Title: Hwy 14:06 Intersection Improvements at Hwy 824:02, South Cooking Lake/RR 221 and RR 220.

Memorandum (or Approval) Date: April 27, 2012 Design Exception Request Date: April 18, 2012

Region: North Central Approval Status: Approved

Design exception 1.

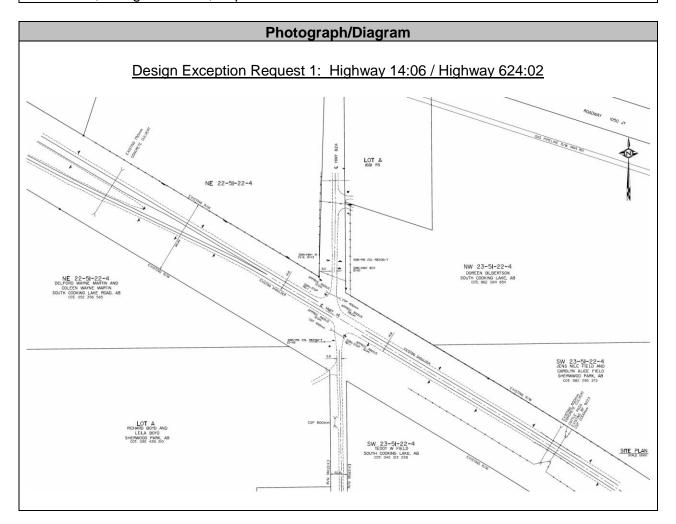
Based on (Alberta Transportation, Highway Geometric Design Guide. 1995, Updated 1999, (ATHGDG) Chapter D.7 and projected 20 year traffic projected volumes, a Type IVb would be warranted at the intersection of Highway 14/ Highway 824. The request is to maintain the intersection in its current Type 1 configuration due to the conflict with the existing transition from two lane undivided highway to four lane divided highway located immediately west of this intersection

- The collision history for the five year period from 2005 to 2009 is considered good with 1 minor injury and 4 PDO. In addition, there has been no rear end type collisions reported for this period.
- Introducing an EB left turn lane may cause confusion motorist and increase workload as they transition from the divided highway section.
- The intersection sight distance of 500 m is adequate for all design vehicles.

Approach sideslopes improvements at the intersection are in accordance with AT's 3R/4R Guidelines, Chapter G.6.4.

<u>Design Exception Request 2: Highway 14:06 / South Cooking Lake Access (SCLA)/ Range Road 221</u>

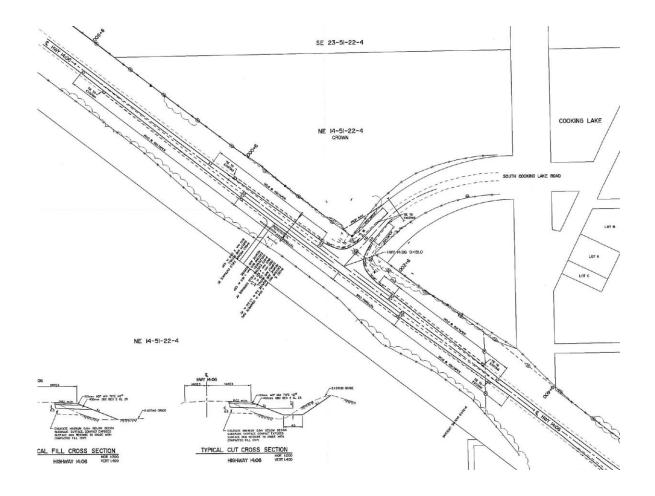
Based on ATHGDG - Chapter D.7 and projected 20 year traffic volumes, Hwy 14/SCLA and Hwy 14/Range Road 221 warrants a Type IVa and Type IIIa intersection treatment respectively. The existing T-intersections of SCLA and Range Road 221 are spaced about 500 m and on opposite sides of highway 14. The warranted typical intersection treatments would overlap each other. The design exception request is to modify the typical intersection treatments to create a separation of about 100m between the two intersection tapers

- The separation of 100m between the two intersection tapers will reduce the amount of weaving and confusion for motorist between the two intersections.
- For a Type IIIa intersection a 87.5 m @ 25:1 deceleration taper is typically used for design speed of 110 km/h. Highway 14:06 is currently posted at 100 km/h.
- The intersection sight distance is over 500 m at both intersections and adequate for all design vehicles.
- The existing Hwy 14/SCLA intersection has a treatment similar to a Type 4a but the tapers and shoulder widths are deficient. Hwy 14/RR221 intersection has a Type 1a treatment. The collision history for the five year period from 2005 to 2009 is considered good at both intersections.

Design Exception Request 3: Highway 14:06 / Range Road 220

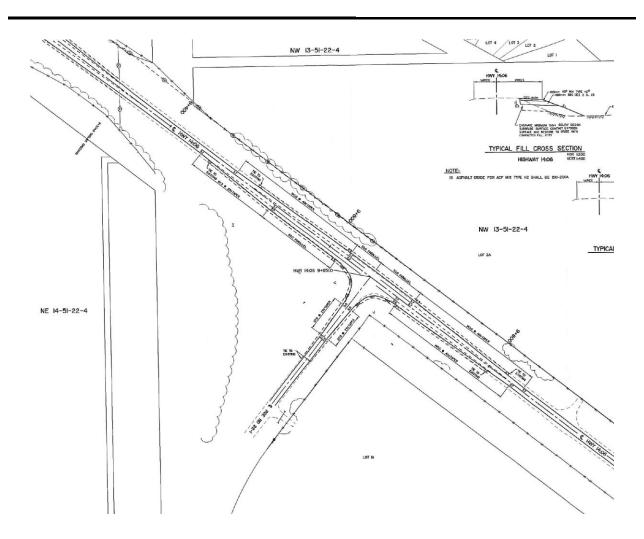
speed and radius as indicated in Table B3.6a of the ATHGDG. The request is for a Type IVb intersection treatment on an existing R1180 m horizontal curve. Based on a design speed of 120 km/h for an intersection on a curve, the existing radius is below the R1800. For major intersection on curves with design speeds greater than 100 km/h, the superelevation rate of 3.2% is also be exceeded.

- The collision history for the five year period from 2005 to 2009 is considered good
- The collision history for the five year period from 2005 to 2009 at the intersection has 4 non animal reported collisions with 2 minor injuries and 2 PDO. Of the four reported collisions, one collision could be attributed to the intersection configuration. The propose Type IVb will improve the safety/ operation for vehicles turning on and off of Highway 14.
- The intersection sight distance (ISD) of 500 m to the east is adequate for all design vehicles.
- The ISD to the west of 460 m to the west is below the 500 m ISD for a WB-21/WB-23 design vehicle. Based on the collision history for the five year period from 2005 to 2009, none of the 4 non-animal reported collisions appear to have been due to the ISD to the west.

Recommend that the intersection be monitored and if require, a WA-11 four legged concealed road sign be installed.
